METROPOLITAN GOVERNMENT OF NASHVILLE AND DAVIDSON COUNTY

Metropolitan Historic Zoning Commission
Sunnyside in Sevier Park
3000 Granny White Pike
Nashville, Tennessee 37204
Telephone: (615) 862-7970
Fax: (615) 862-7974

STAFF RECOMMENDATION 1511 Fatherland Street February 20, 2013

Application: New construction – primary building and accessory building
District: Lockeland Springs-East End Neighborhood Conservation Zoning Overlay
Council District: 06
Map and Parcel Number: 08313040900
Applicant: Jeremy Bockman, Developer
Project Lead: Sean Alexander, sean.alexander@nashville.gov

SITE PLAN
NO SCALE

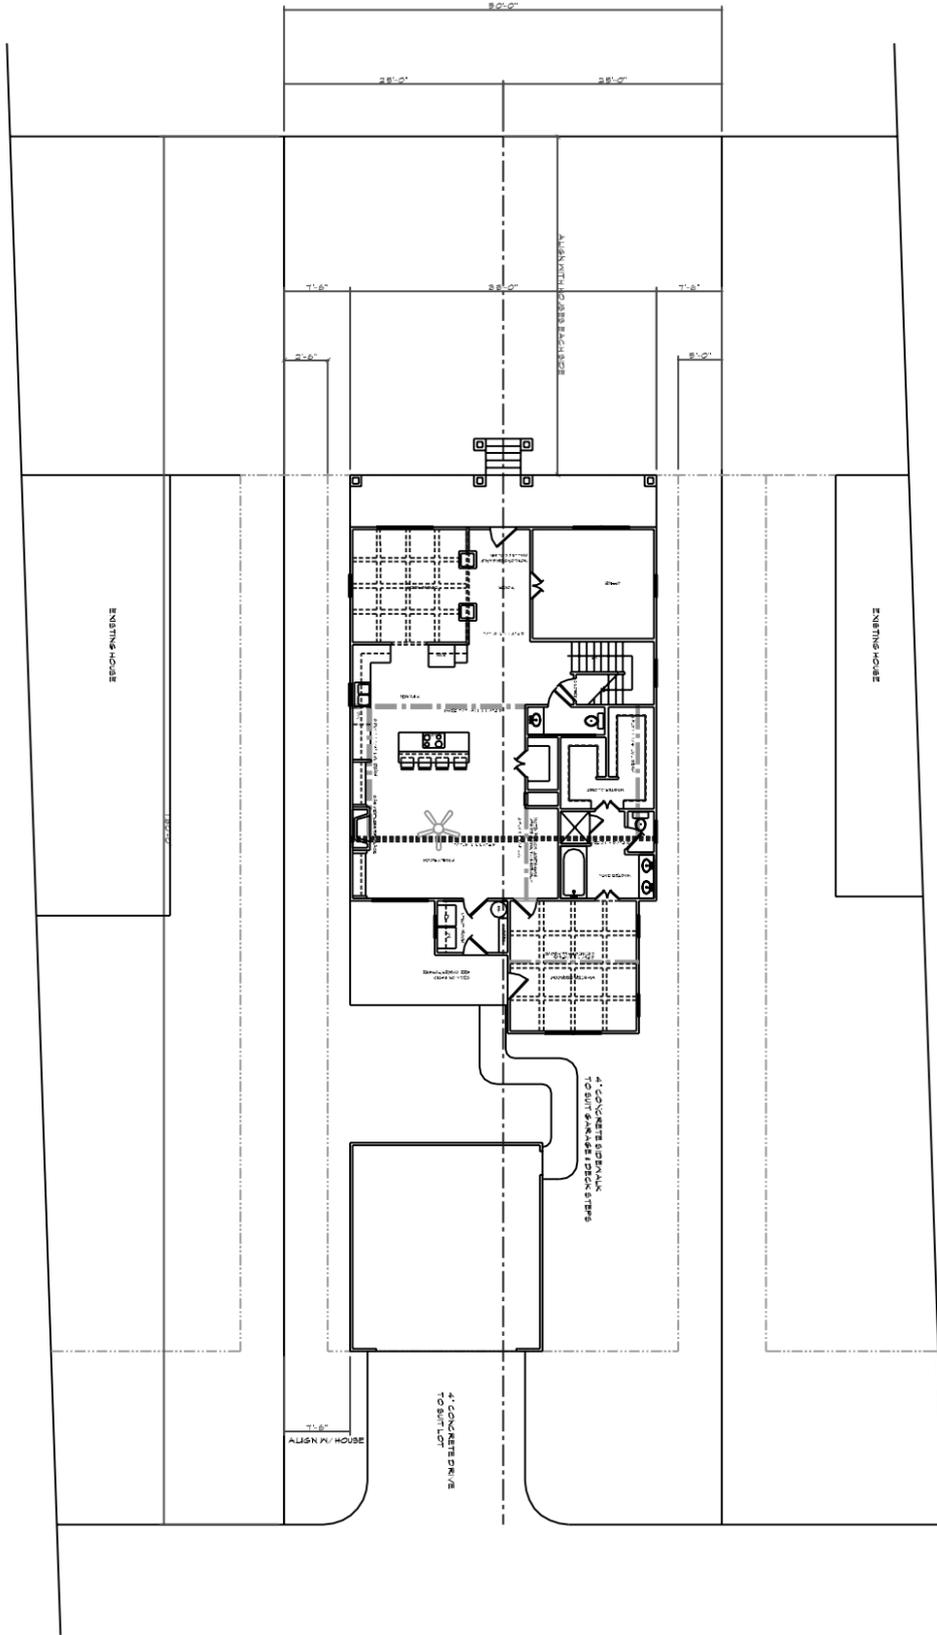
The site plan is not to-scale but notes that the front setback will be in alignment with the homes on either side. The side setbacks are also unknown but appear to meet the bulk zoning requirement of a minimum of five feet (5').

- A scaled site plan be submitted;
- The double windows have at least a four inch (4") mullion between;
- Utilities be located beyond the midpoint of the house;
- Staff provide final review of windows, doors, porch materials and roof color; and
- A walkway be added from the front steps to the front sidewalk.

TWIN TEAM INVESTORS 1511 FATHERLAND	Date	12/10/2012	 DESIGN SERVICES	GARY L. FOLLIS 7301 Del Thomas Road Smyrna, Tennessee, 37167 615-593-7912	Drawing Number A-1	Rev. No. 0
	DrBy	GLF				
	Rev					
	Job#	57-2012				
Scale:	FRONT & REAR ELEVATIONS

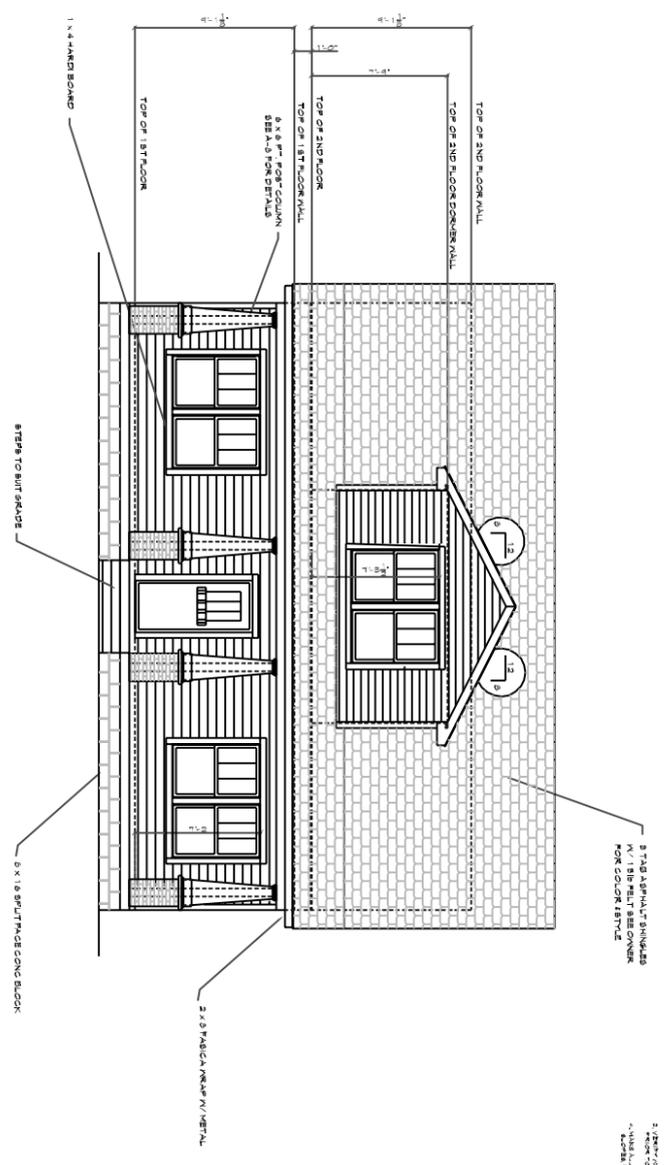
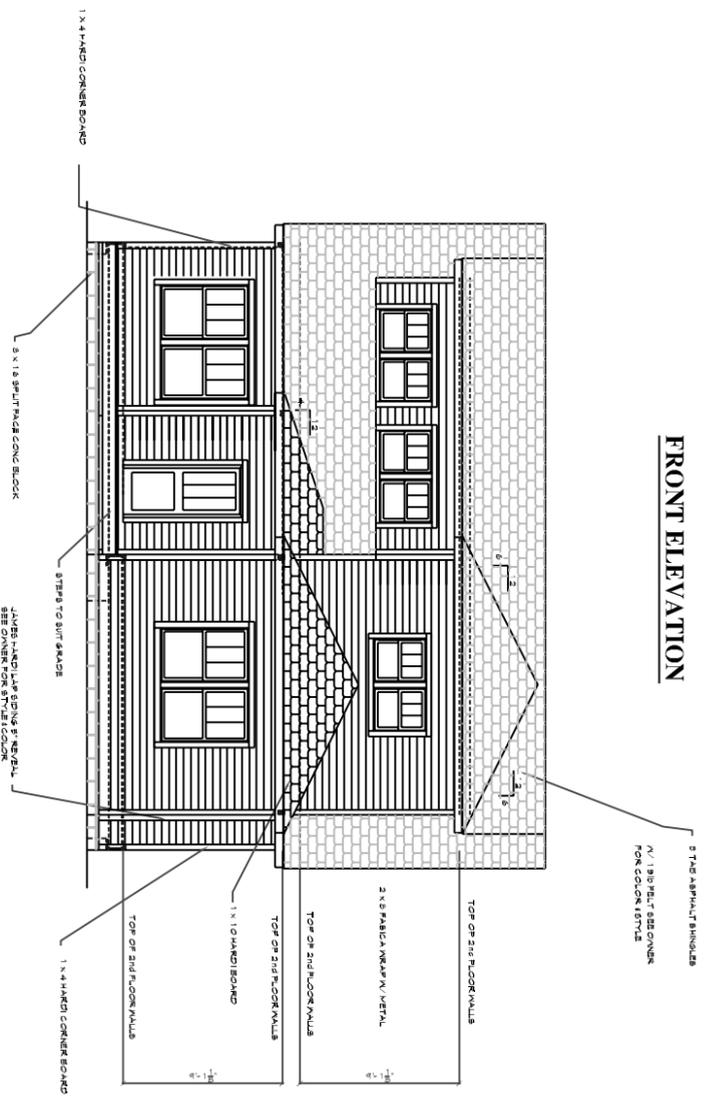
The primary roof, a side-oriented gable, will have a pitch of 8:12, as will the front gabled dormer. These roofs are compatible with those of historic houses nearby and meet guideline II.B.5.

The front elevation will have a typical Craftsman window pattern with three-over-one windows. The majority of windows are twice as tall as they are wide, which matches the proportion of windows on historic homes in the district. The rhythm of window openings will also be similar to a Craftsman style, although the window sizes will be less uniform. The longest expanse without an opening is approximately twenty-feet (20'); however, this takes place beyond the midpoint of the house where it will have a minimal visual impact. Staff finds the window rhythm to meet guideline II.B.7, with the condition that four inch (4") mullions are added between paired windows, as would be typical of windows on historic houses.
